UNITED STATES PATENT AND TRADEMARK OFFICE

APPLICATION NO.	FILING DATE	FIRST NAMED INVENTOR	ATTORNEY DOCKET NO.	CONFIRMATION NO.
10/601,701	06/24/2003	Ching-Fa Yeh	BHT-3230-56	7550

Office Action Summary

FIG. 1

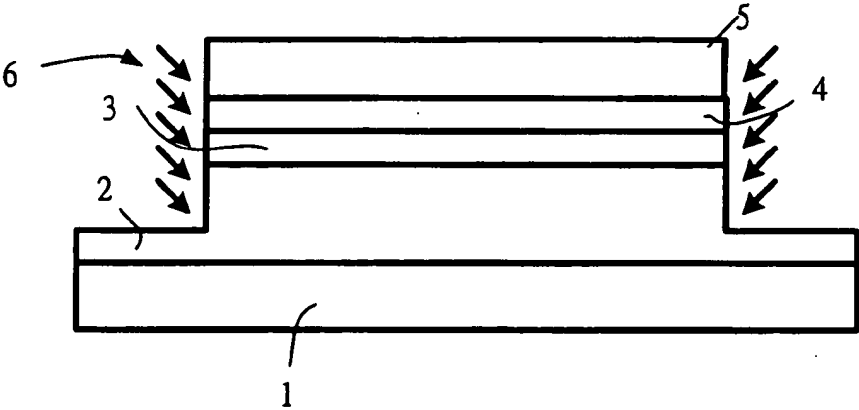
The drawings are objected to under 37 CFR 1.83(a). The drawings must show every feature of the invention specified in the claims. Therefore, the active layer must be shown, specifically in figures 1-3 or the feature(s) canceled from the claim(s). No new matter should be entered.

35 U.S.C. 112, first paragraph, requires the specification to be written in "full, clear, concise, and exact terms." The specification is replete with terms which are not clear, concise and exact. The specification should be revised carefully in order to comply with 35 U.S.C. 112, first paragraph. Examples of some unclear, inexact or verbose terms used in the specification are: For example, on page 4, lines 22-24, "d) process, a thermal insulating layer of laser annealing or a hard mask of the removal pf polysilicon spacer after recrystallization;" is unclear in its meaning. In addition, on page 4, lines 25-28, "using a solution of silicon dioxide 6 of wet isotropic etching ..." How is this possible? Especially since conventionally wet etching techniques may be used to etch silicon dioxide. Finally, on pages 5-6, lines 10-11, 21-22 and 1-3, respectively, "the polysilicon spacer 7" is disclosed as being "behind either side of the active layer", "under either side of the active layer" and "to be surrounded the side of active layer" it is unclear what is the meaning with regards to the location of the "polysilicon spacer 7". According the disclosed figures 1-3, it appears that the "polysilicon spacer 7" is on either side of

"the amorphous silicon layer 3", however, it is unclear what direction exactly where is the active layer, etc. Clarification is requested.

Enclosed are new formal drawings of Figures 1-7, accompanied by a LETTER TO THE OFFICIAL DRAFTSPERSON. Figure 1 was amended to correct the reference line for reference number "6", and the words "Wet Etching" were deleted.. Figure 2 was amended to properly identify reference line with reference numbers "1", "2", "3", "3a", "4", "7", and "8", and the words "Dry Etching" were deleted. Figure 3 was amended to add reference number "15", and the words "Excimer Laser Recrystallization" and "Direction of Grain Growth" were deleted. Figure 4 was amended to replace the words with reference numbers --7--, --10--, --11--, and --12--. Figure 5 was amended to replace the words with reference number --7--. Figure 6 was amended to replace the words with reference numbers --7--, --13--, and --14--. Figure 7 was amended to replace the words with reference numbers --7--, --10--, --11--, and --12--, and add the label --Prior Art--.
